Seismic Walkdown Checklist (SWC)

Equipment ID No. 1-2403-64-001-V02 Equip. Class¹² Z1 - Tanks and Heat Exchangers
~~H7 - Engine Generators~~ W.S. 8/28/12

Equipment Description DG AIR START RECEIVER

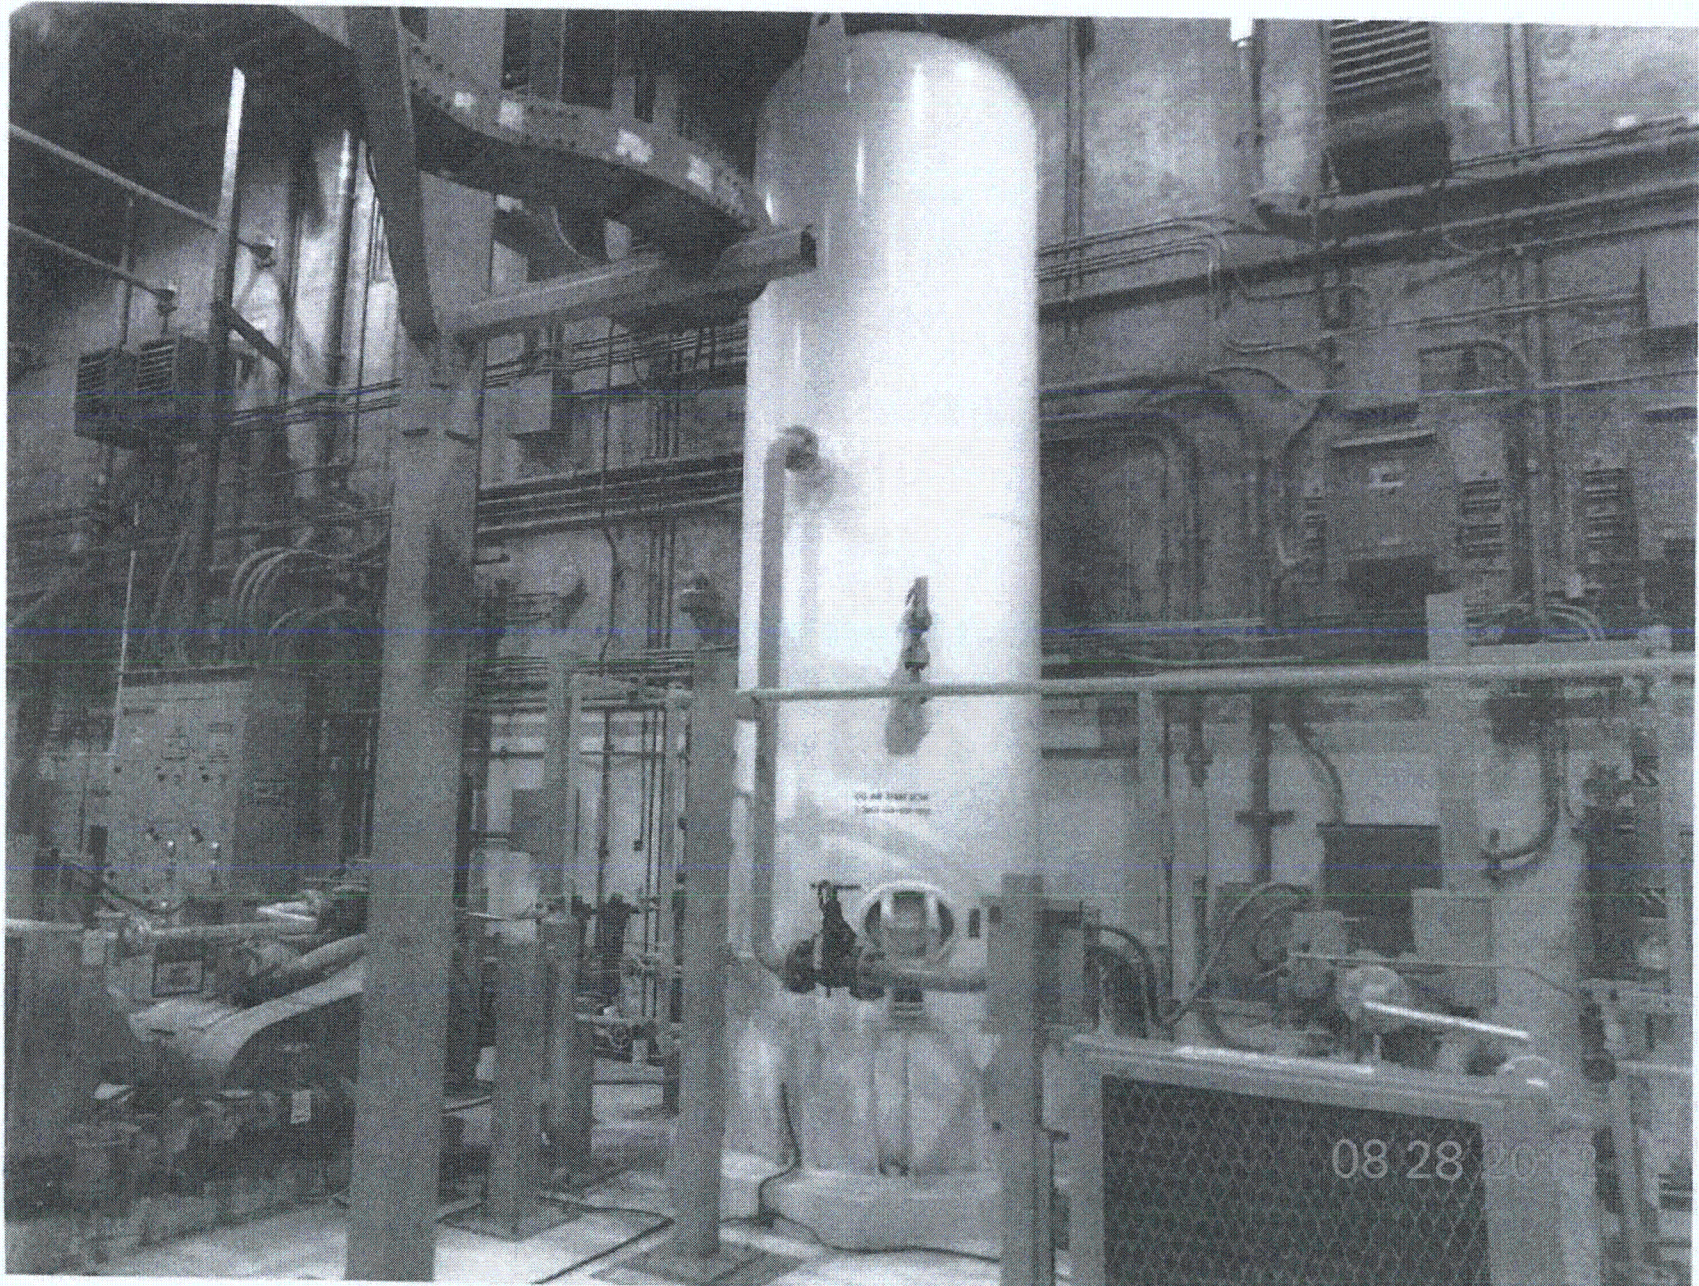
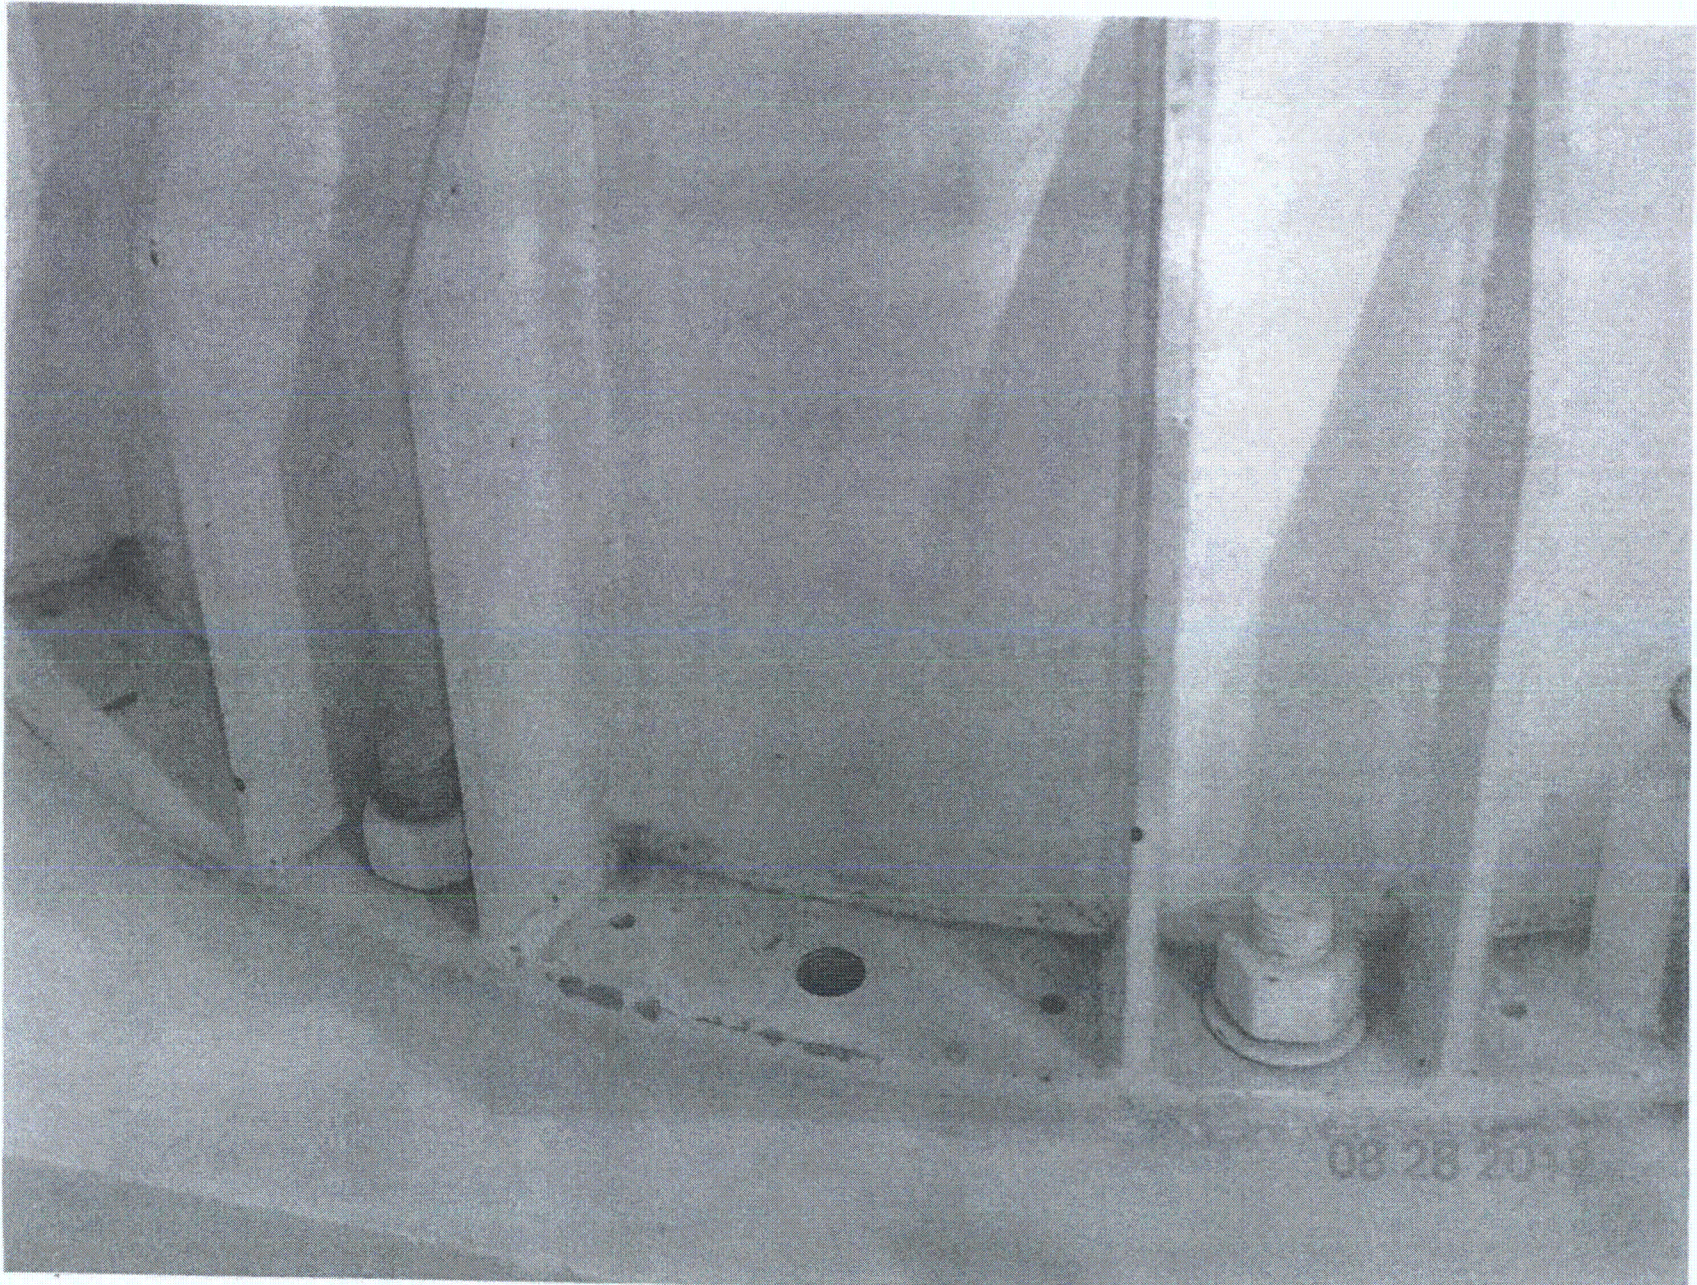
2. Is the anchorage free of bent, broken, missing or loose hardware? Y N U N/A
2 OF 12 BOLTS MISSING WASHERS REF CR # 540.134
SLIGHTLY OUT-OF-PLUMB A.B's (<2°)
ABOVE ITEMS ARE NOT SEISMIC CONCERNS
3. Is the anchorage free of corrosion that is more than mild surface oxidation? Y N U N/A

Equipment ID No. 1-2403-P4-003 Equip. Class¹² 6 (vertical Pump)
Equipment Description Diesel Fuel Oil Transfer Pump

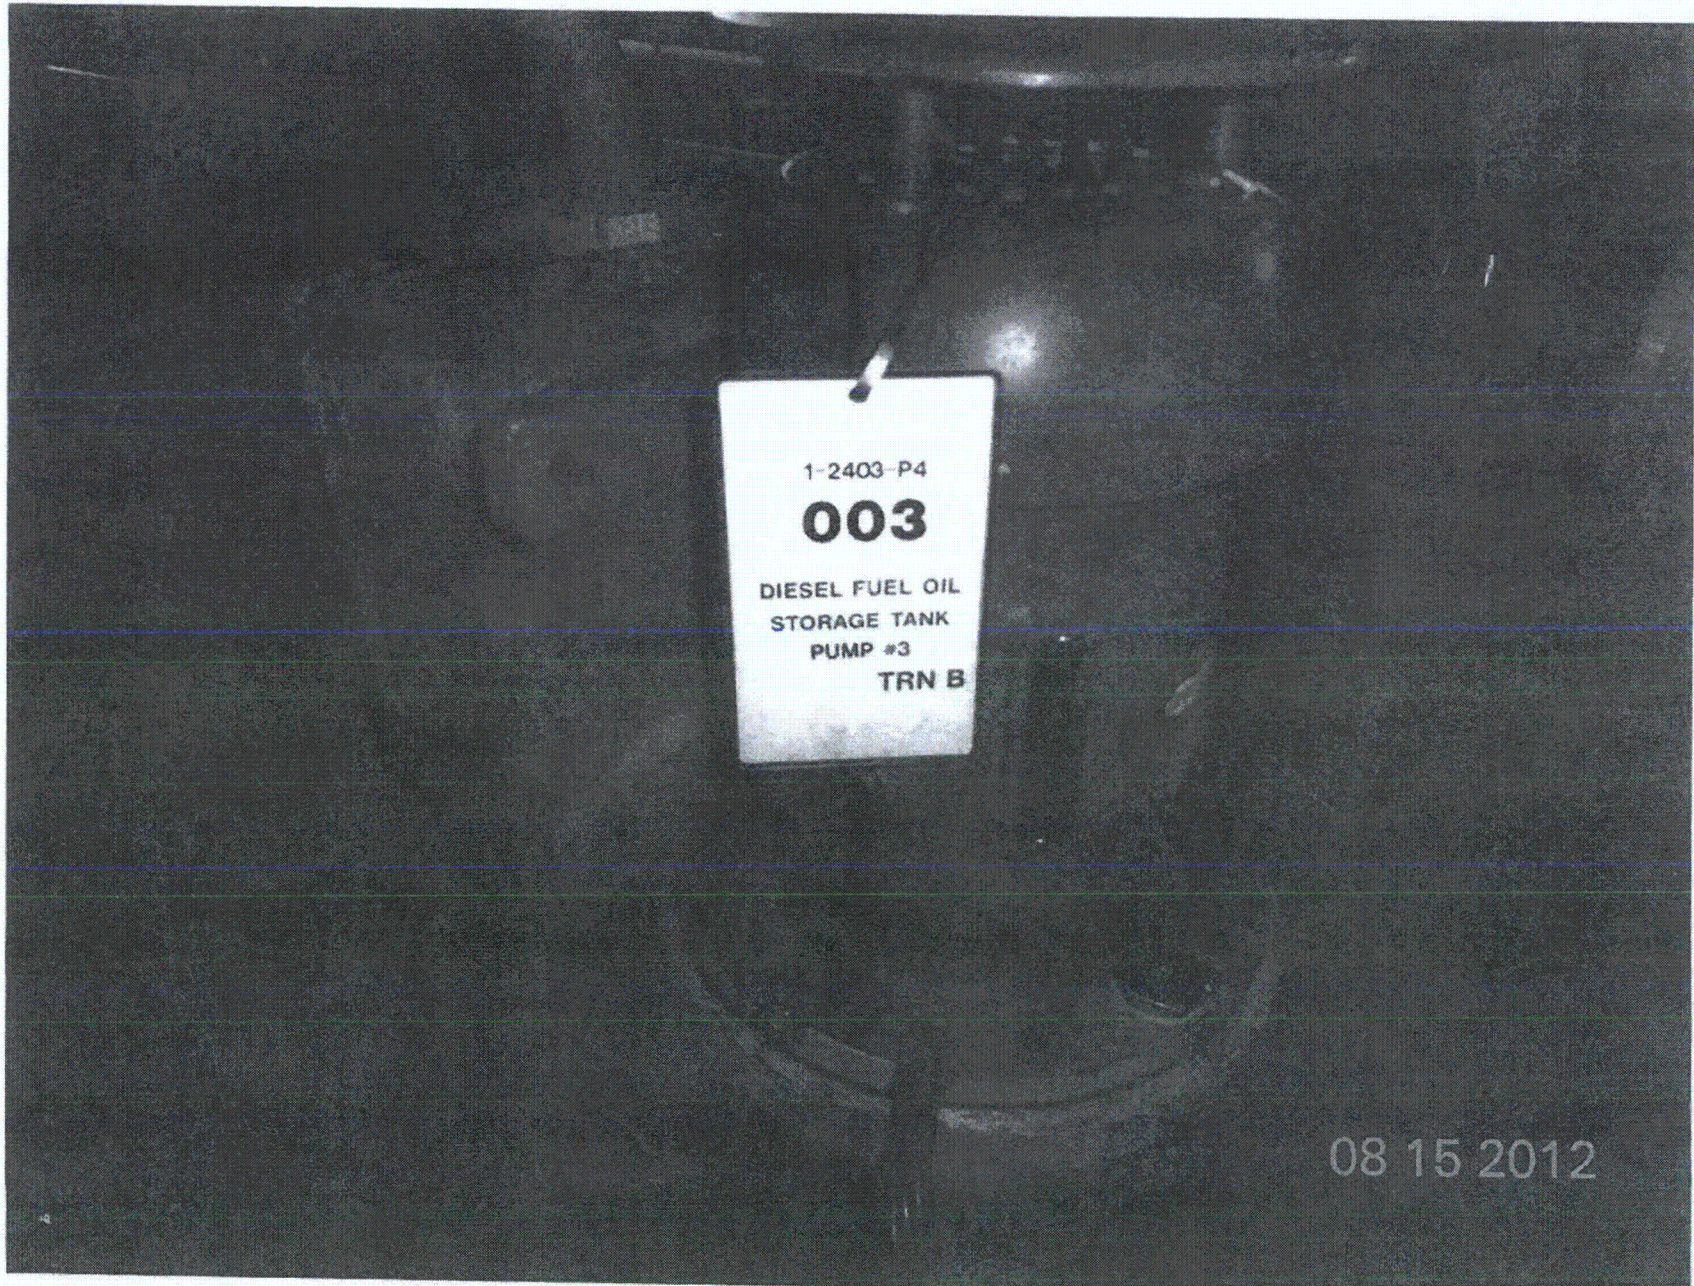
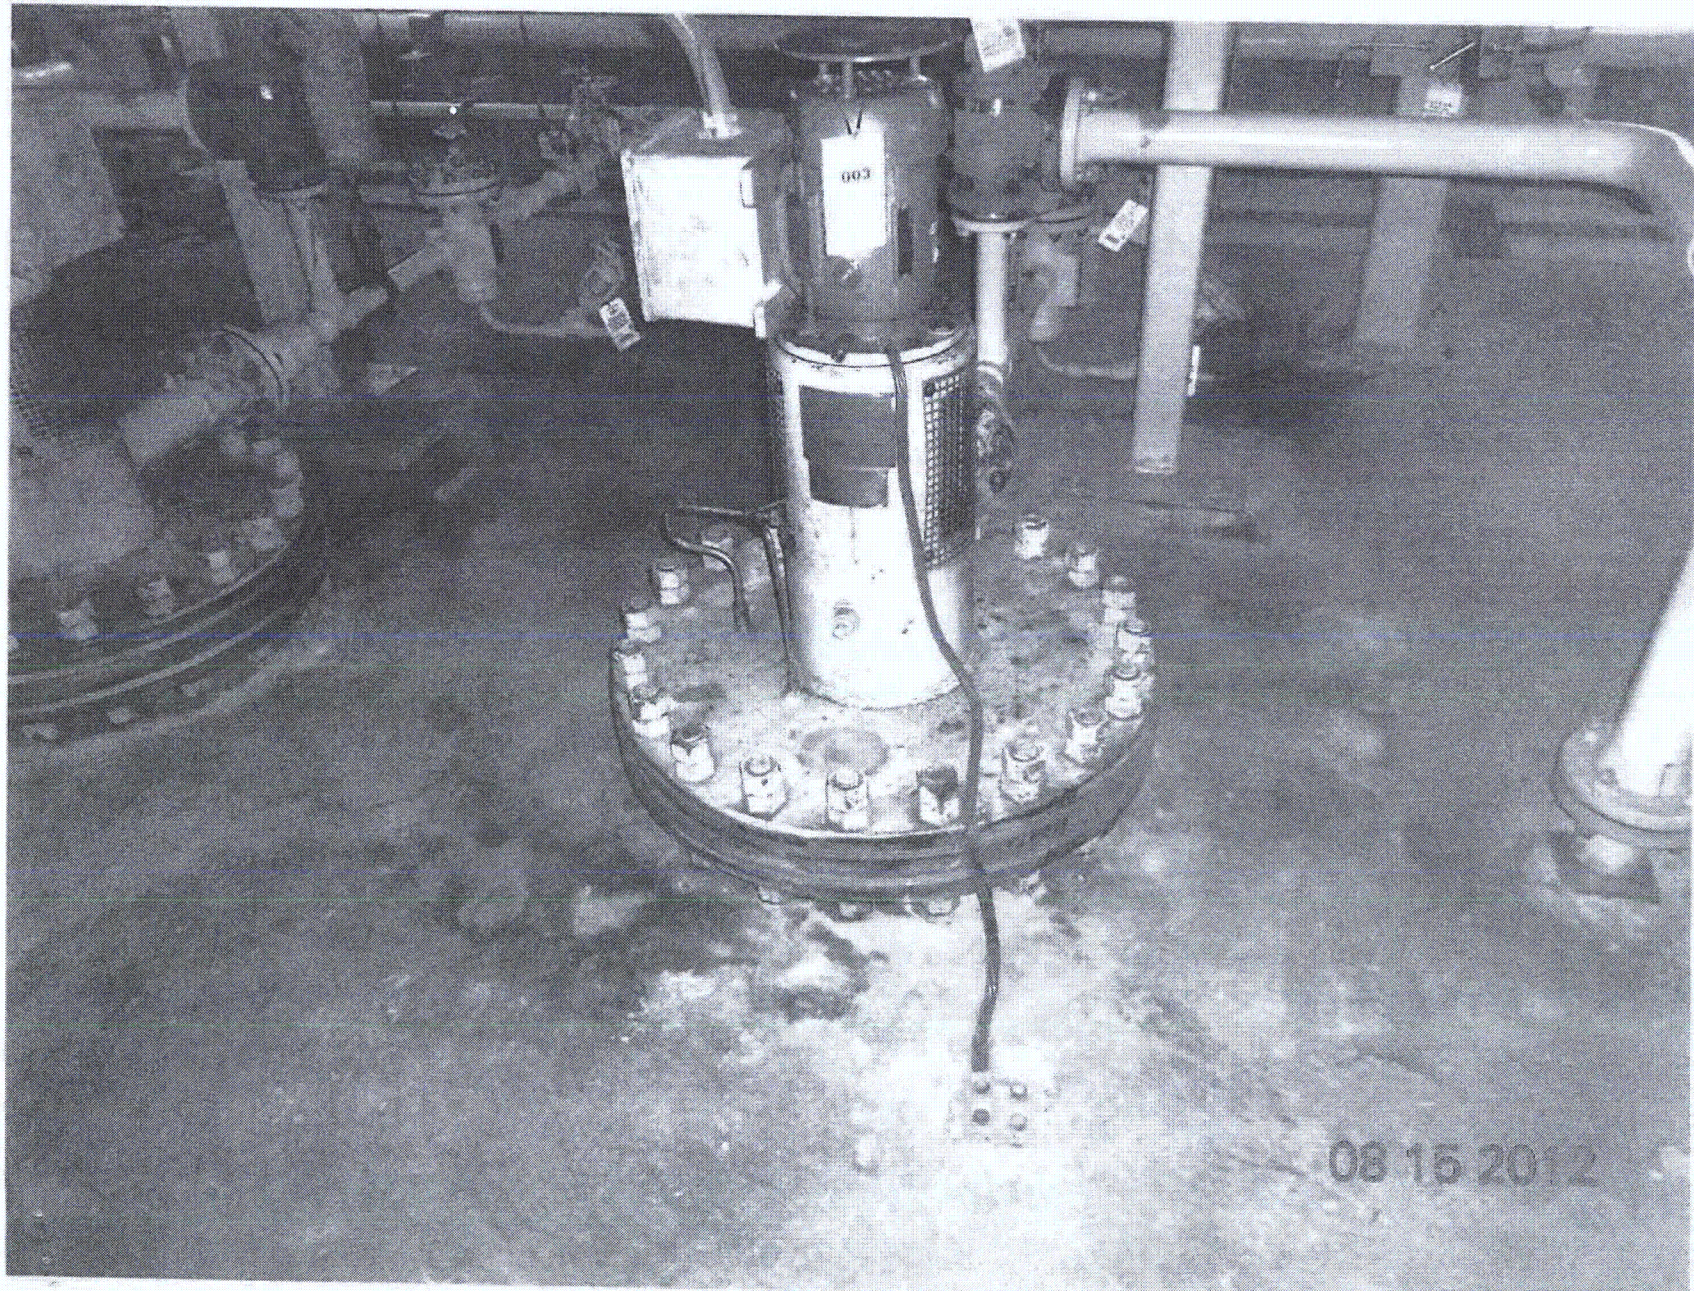
4. Is the anchorage free of visible cracks in the concrete near the anchors? Y N U N/A
*No cracks at nozzle penetration at all visible areas.
 Note: this is not actually anchorage for pump, but at tank nozzle penetration below flanged connection to pump.*

5. Is the anchorage configuration consistent with plant documentation? Y N U N/A
 (Note: This question only applies if the item is one of the 50% for which an anchorage configuration verification is required.)
*Checked flange bolts
 Drawing # IX41AF04-00010-01
 NOT required, but flange configuration is consistent with drawing*

Equipment ID No. 1-2403-PS-063 Equip. Class¹² 20 (INSTRUMENT & CONTROL PANEL)

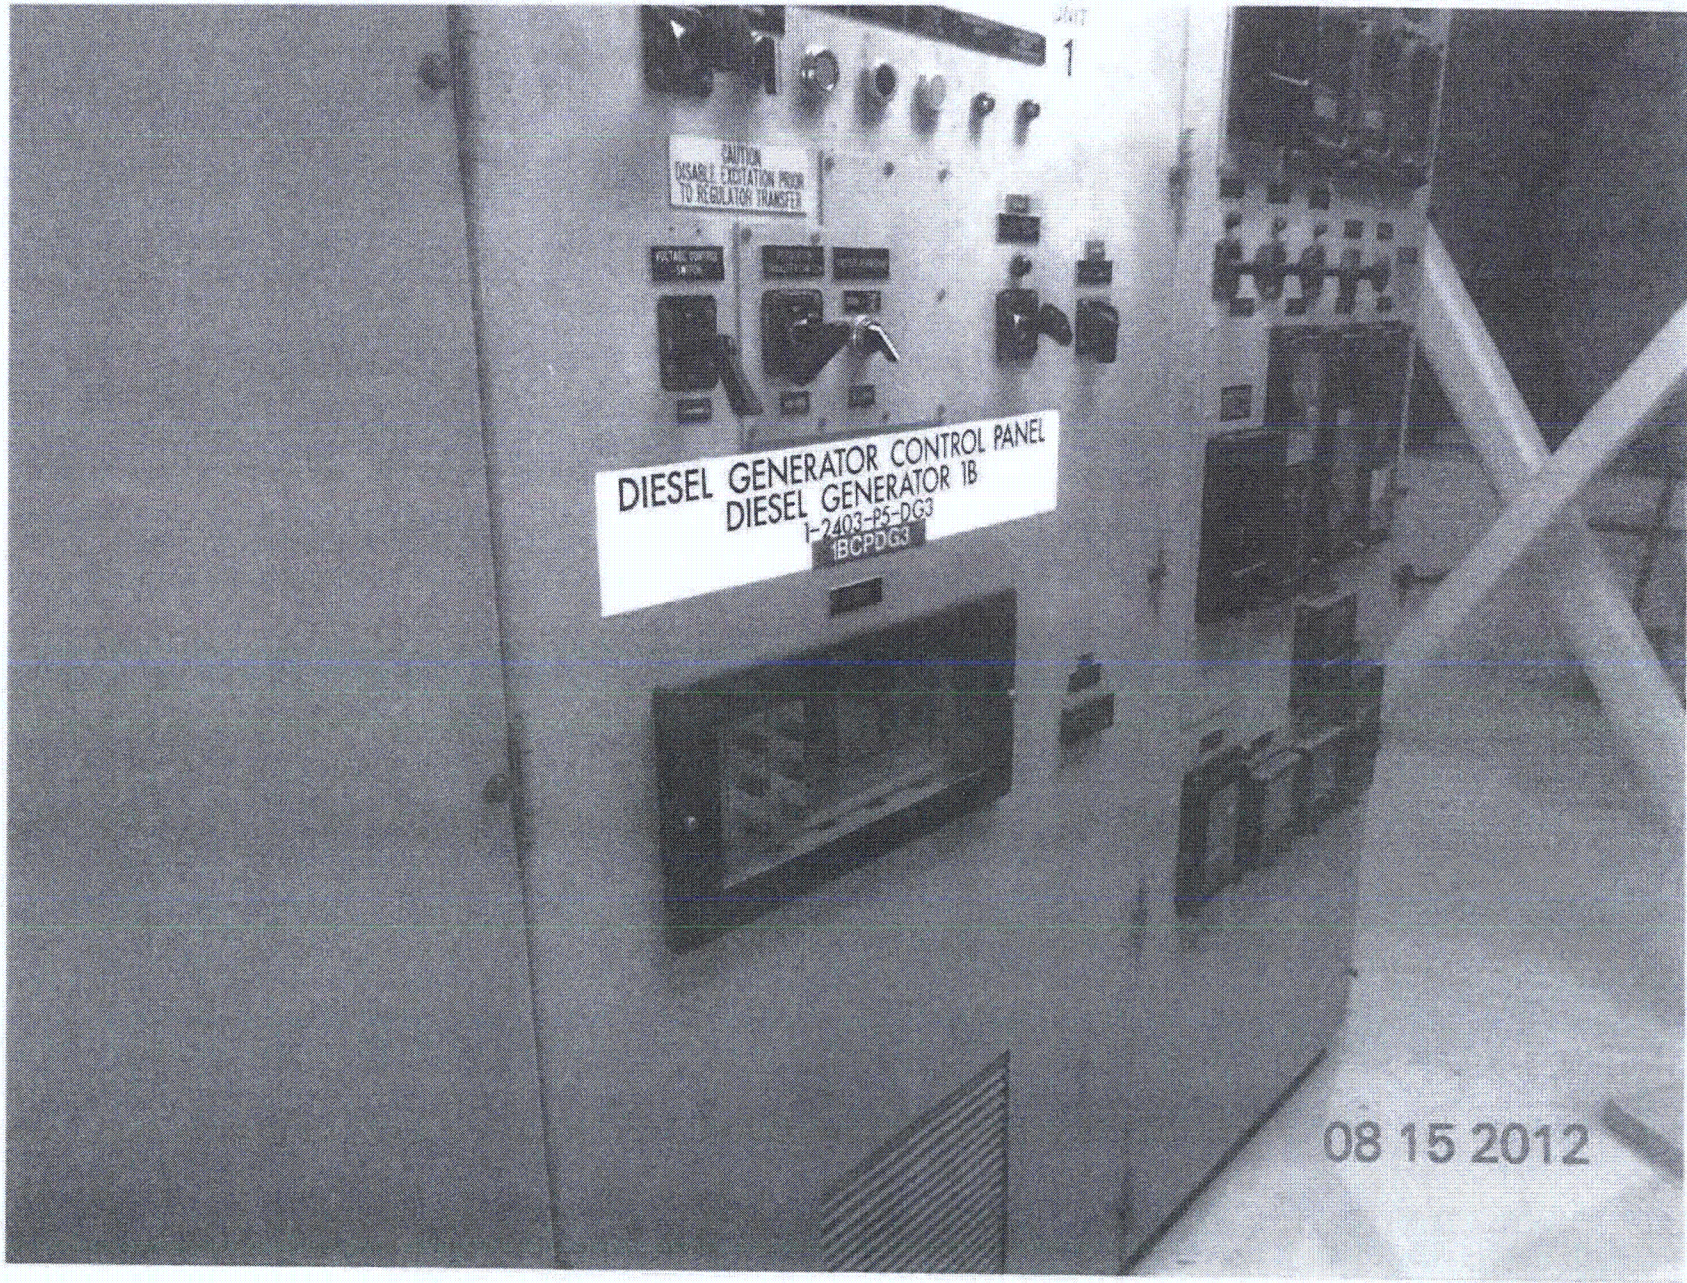
7. Are soft targets free from impact by nearby equipment or structures? Y N U N/A
COVER FOR LIGHT FIXTURE IS LOWIE - NOT SEISMIC CONCERN - SEE CR 504856
HANGING CONTROLLER CABLE IS STRAPPED TO STRUCTURAL STEEL
NOT A SEISMIC CONCERN - SEE CR 504859

8. Are overhead equipment, distribution systems, ceiling tiles and lighting, and masonry block walls not likely to collapse onto the equipment? Y N U N/A
LIGHT FIXTURES HAVE OPEN HOOK DESIGN
WILL NOT IMPACT CONTROL PANEL
NOT A SEISMIC CONCERN
